**CONTRACT DOCUMENTS
BOONE COUNTY, MISSOURI
BID NO: 35-04MAY06 Schooler Road Paving Improvements**

**ADDENDUM #1
(Issued April 25, 2006)**

Addendum #1 - 4/24/06
Schooler Road - Paving Improvements
Clarification of Detail at State Route 124

SECTION DETAIL #1
NOT TO SCALE

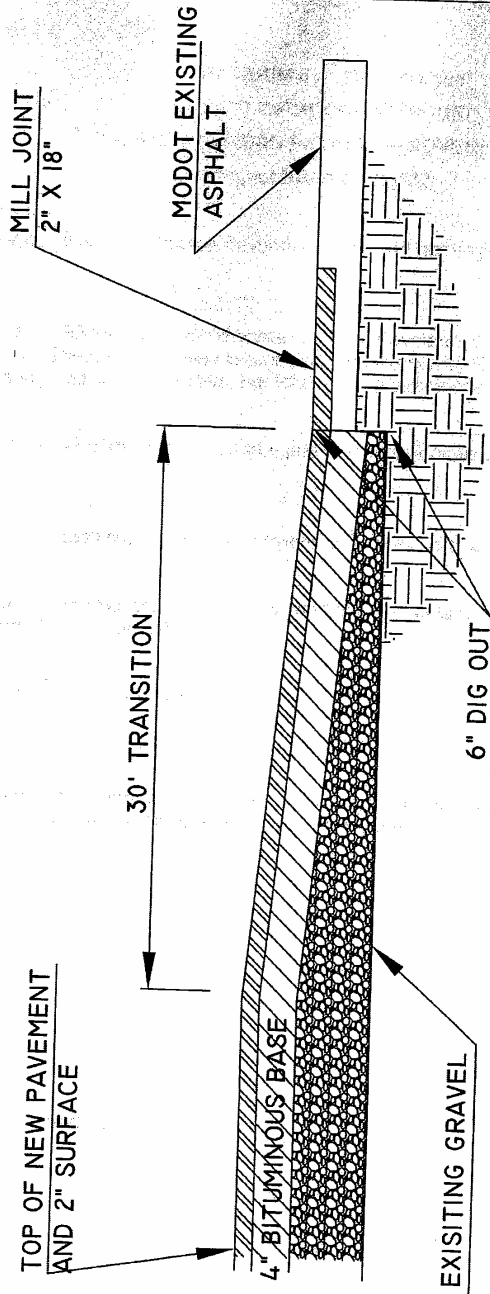
5. **Clarification:** See Section Detail # 2 for clarification of detail at intersection of Schooler Road and State Route 124.
